Petition Number: 2025-070 General Location Identifier: 03736123

Date	Description
8-28-2025	First Review (IW)
9-24-25	Second Review (IW)

### **Transportation Summary**

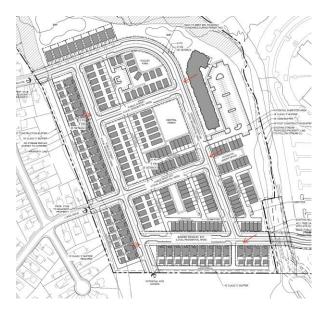
- 7. Outstanding Comment from 8/28/25: NCDOT REQUIREMENT: Revise site plan and conditional note(s) to commit to a 50' right turn lane on Beatties Ford Road in coordination with NCDOT. Add a conditional note committing to this improvement and further coordination with CDOT and NCDOT during permitting. Site plan shall dimension, and label right turn lane from the roadway centerline.
- 8. Outstanding Comment from 8/28/25: Revise site plan and conditional note(s) to commit to extending the sidewalk on Banner Ridge Blvd to Beatties Ford Road.

Outstanding Comment from 8/28/25: Revise site plan and conditional note(s) by adding pedestrian ramps to the intersections within the proposed development. You may need to adjust some of the on street parking stalls to accommodate.
